**Re: PROTEST of Proposed Resource Management Plan Amendment / Final
Environmental Assessment**

**Morongo Canyon Highway 62 Multi-Tenant Wireless Broadband
Communications Site**

NEPA #: DOI-BLM-CA-D060-2020-0005-RMP-EA

RE: The Morongo Canyon at Hwy 62 Multi-Tenant Wireless Broadband Communications Site
DOI-BLM-CA-D060-2020-0005-EA

Panorama from Hess Fire (above) and with Google Earth overlay representing height of tower as yellow line (below), based on tower coordinates of 34°2'29.69"N, 116°35'47.71"W and height at 3054' AMSL,

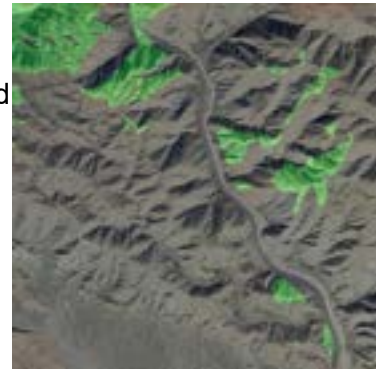
1. Wildfire risk was a concern raised by the community during the Public Scoping period, but it is not addressed in the EA. The proposed project has a potential to increase the wildfire risk in the region, including by way of the following elements:
 - a. inclusion of 3,000 gal of fuel storage near homes;
 - b. 196' tall tower as an obstacle to air support during a wildfire;
 - c. far distance to an existing fire hydrant - over 1500' host pull from Matzene and Manana;
 - d. scarcity of resources (personnel, water, pressure); and
 - e. likely increase in unauthorized OHV.
2. Below photographs from Hess Fire on May 15, 2024 show low-flying aircraft and proposed project site from the same stationary vantage point at Conejo Rd/Hess Blvd;

demonstrating the potential for tower to interfere with aerial support during fire suppression efforts

11-6-2023, from 11568 Pinon Ave looking west with project site located on top of ridge

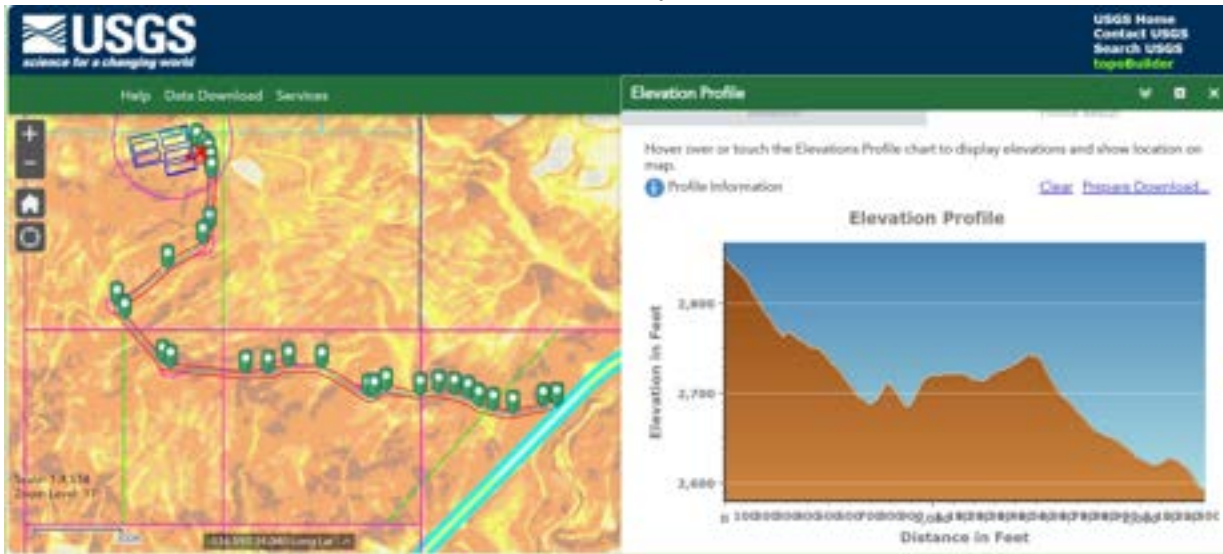
1. Amending the RMP to downgrade the VRM class would undermine the land planning objectives which were [intended to protect our scenic values](#).

2. Key Observation Points (KOPs) fail to adequately portray the scenic value of existing conditions.
 - a. KOPs with telephone poles in foreground downplay the degree of change considering an affected resident would be viewing from within their home or a scenic vantage point as opposed to from the street. KOPs should try to avoid angles with utility poles or other obstructions in the foreground.
